Staff Report & Recommendation

SUBJECT: **PB20-0357. 1910 Alton Road – Mechanical Parking**

An application has been filed requesting conditional use approval for a new 5-story mixed-use building, including the use of a mechanical parking, pursuant to Chapter 118, Article IV, and Chapter 130, Article II of the City Code.

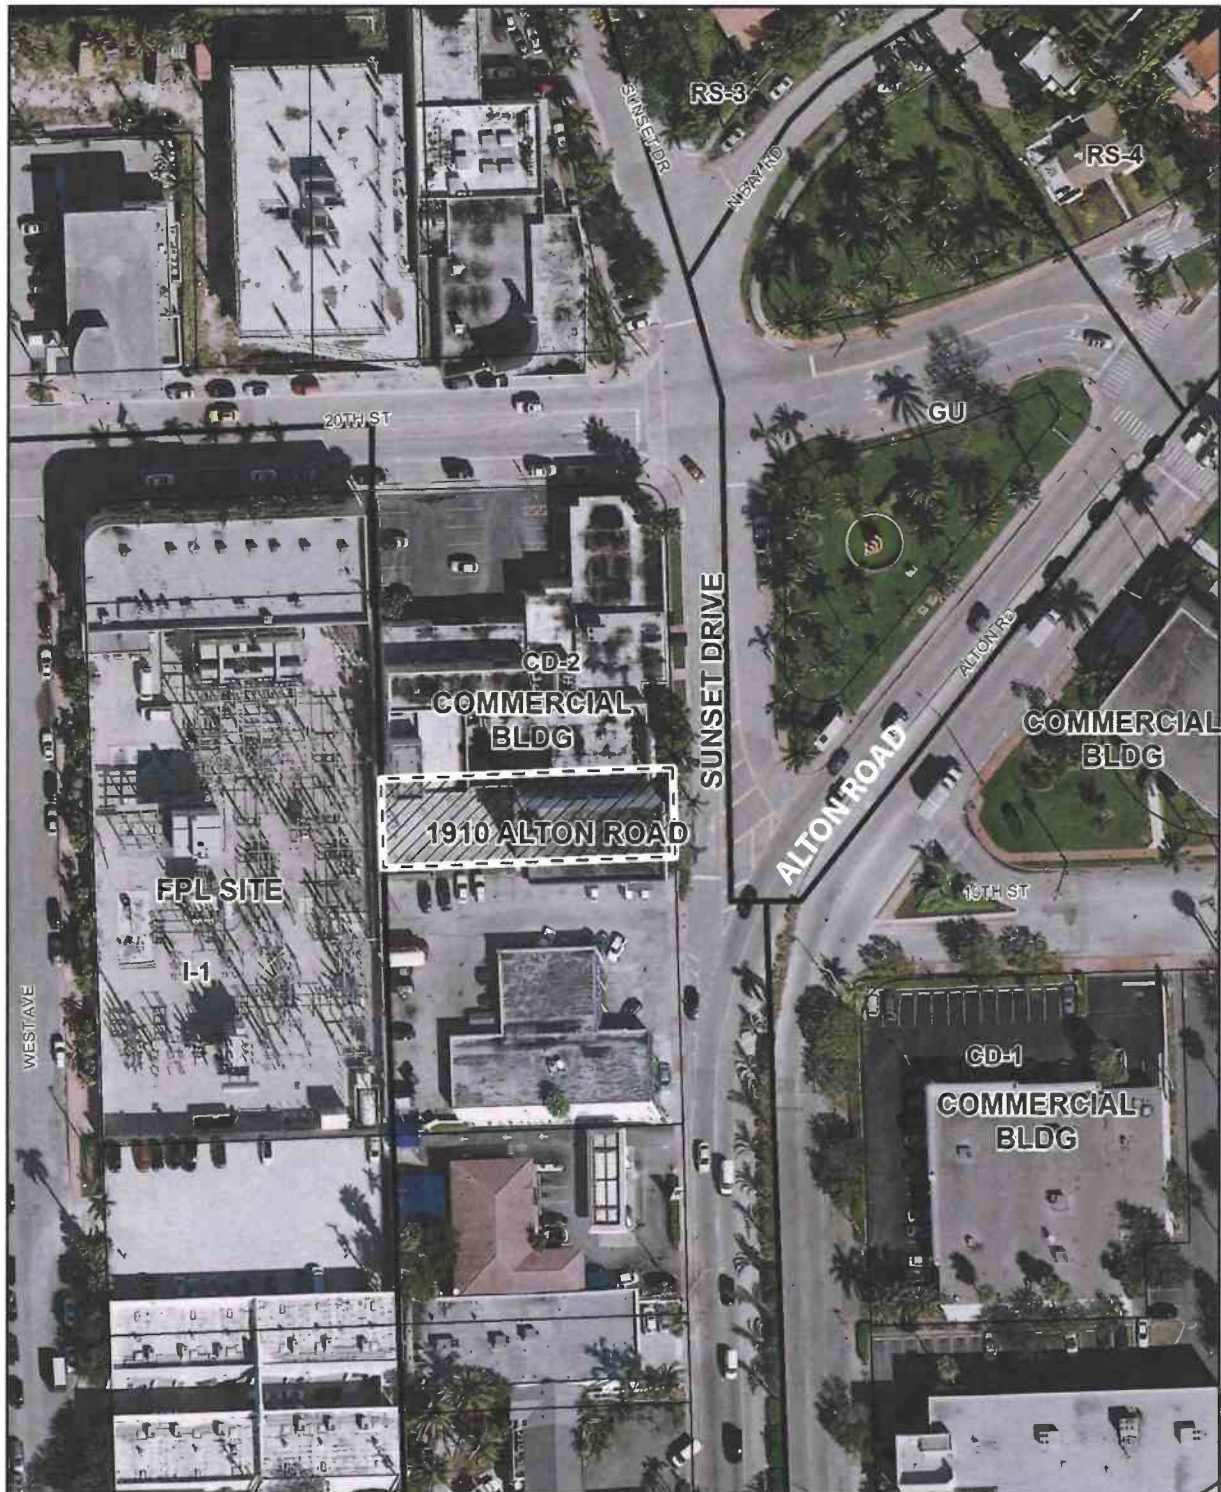
Because there is no alley behind this property, all sanitation and deliveries will be done from the Sunset Drive/Alton Road driveway. Staff is concerned that no internal turnaround has been provided on-site, and with the resulting interruption in vehicular traffic that may result. Removing one set of lifts and utilizing this area will allow room for a turnaround area, which staff is recommending as a condition of approval.

- a. A turnaround area shall be provided on site for delivery vehicles. This may be provided by removing one set of mechanical lifts, subject to the review and approval of staff.
